07-ESQ-048

PROPOSED TRANSITION PERIOD FOR IMPLEMENTING REVISED PROCESS FOR PERMIT INCORPORATION OF DESIGN DOCUMENTS AT THE WASTE TREATMENT AND IMMOBILIZATION PLANT (WTP)

Subject: Alternate DWP 2+2 Permit Condition for Design Submittals

HAZARDOUS WASTE PERMIT
DRAFT 2+2 PERMIT MODIFICATION
WTP COMMENTS

Attachment 3: DWP Engineering Docs Flow Sheet

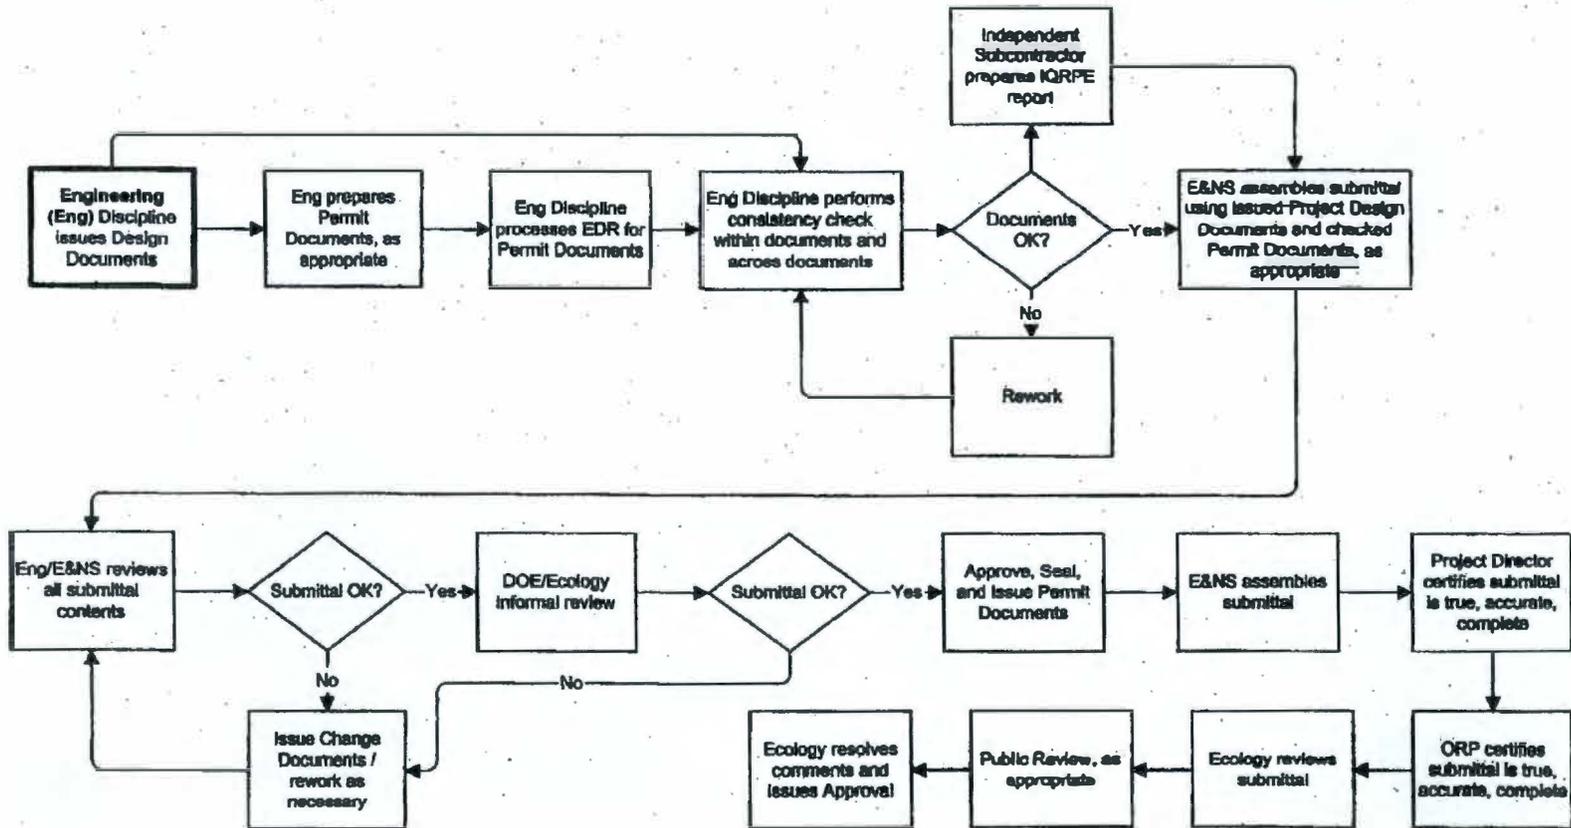
Review of Permitting Process Diagram: Brad Erlandson presented a draft permitting process diagram and discussed how permit modifications could be made using source drawings. The following key points were discussed by meeting participants:

- Source documents (e.g., drawings, mechanical data sheets, specifications) would be submitted to ORP/Ecology without being PE stamped. Drawings would not be

bolded or ghosted satisfying Ecology's objective of maintaining configuration control in the permit of both waste management and support systems. Unique permit documents (e.g., flooding volume, leak detection, hydrogen generation, etc.) still will be used where there isn't a single source engineering document. These documents would not be PE stamped, but review and issuance of these documents would otherwise be unchanged.

- DOE and Ecology comments on an issued design document (e.g., drawing) would be dispositioned with the commenter, and as appropriate, a formal action tracking item (ATS) or a design change document (e.g., drawing change notice (DCN)) would be issued to resolve the comment and/or incorporate the comment into the design. If a design change were required, the document or drawing would be reissued in accordance with engineering procedures (e.g., after 10 DCNs accumulate).

- Approved design change documents that have not been incorporated into the engineering document will be included in the permit package or PCN for information, but would not be incorporated into the permit. As permit documents are revised in accordance with BNI's internal processes (e.g., after 10 DCNs accumulate for a drawing), a PCN incorporating the updated permit document would be submitted.

- WTP would continue to submit approved design change documents (e.g., DCN, SCNs, FCRs, etc.) and non-conformance reports electronically to Ecology in the weekly "milk-run" in accordance with existing permit conditions and Ecology would identify any changes requiring permit modifications. The Permittees will continue to alert Ecology to any such change documents that are considered important enough to require a record of Ecology's concurrence or disapproval prior to construction or installation.

- Construction would progress in accordance with the approved drawing in the permit and the design changes provided to Ecology.
- Following revision and issuance of an engineering drawing it would be resubmitted to ORP and Ecology with a Permit Change Notice (PCN). DCN's associated with a drawing can be identified in DOC Search. Don Sommer does these searches routinely and offered to demonstrate for anyone who is interested. Don indicated search results can be pasted into an Excel spread sheet for easier sorting. Lori Huffman suggested it might not be necessary to resubmit every drawing each time it is revised for incorporation into the permit. Ecology did not agree with this, each document should be submitted for incorporation into the permit as it is revised by the Permittee.
